Re: Comment Response Letter

**Preliminary Plat**

16-197: Fox Creek Subdivision

Figure 1

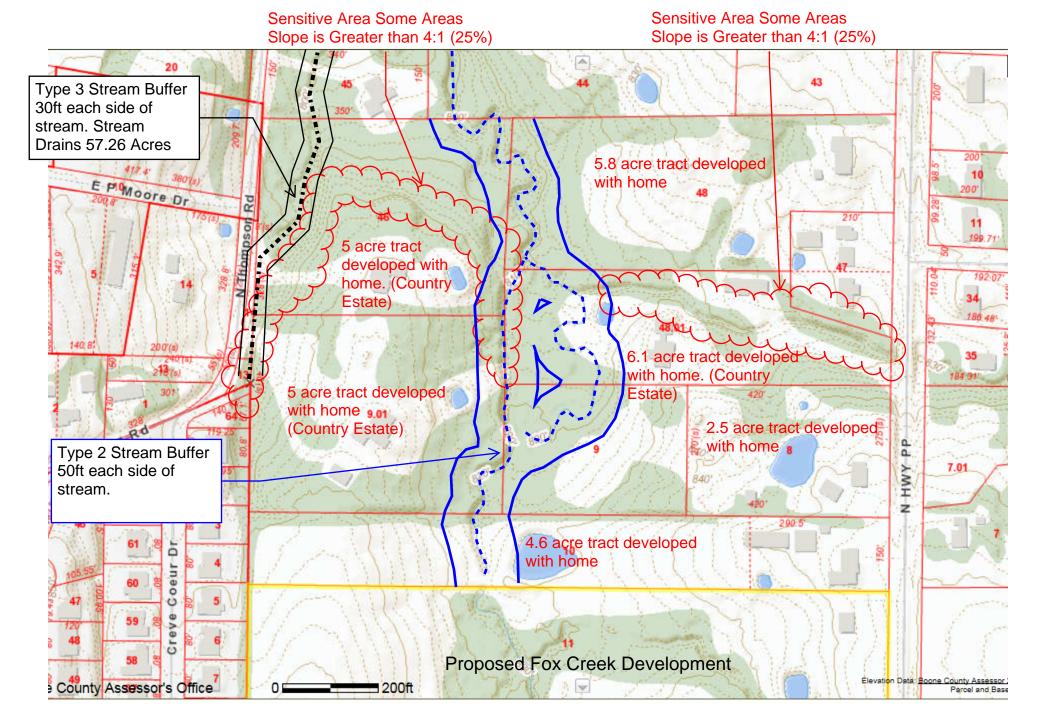
Thank you for your plan review comments received via email on September 27, 2016. In response to a request for a street stub to the North of the Fox Creek Development, I have reviewed the ordinance and would like to state a case that a connection to the North is unnecessary and inappropriate.

City ordinances related to stream buffers and sensitive areas will also prevent development to the north of this property. See Figure 1. The existing stream buffers located north of the development would impair a future development of these tracts of land into a subdivision. Not only do these stream buffer restrictions prohibit future development the future UDO restrictions for "sensitive areas" will also prevent the northern property from development. The majority of the western half leading to Thompson Rd and central portion have an average slope varying from 3.75ft :1 (26%) to 4ft:1 (25%), thus being classified as a sensitive area. These sensitive areas would prevent development to the north.
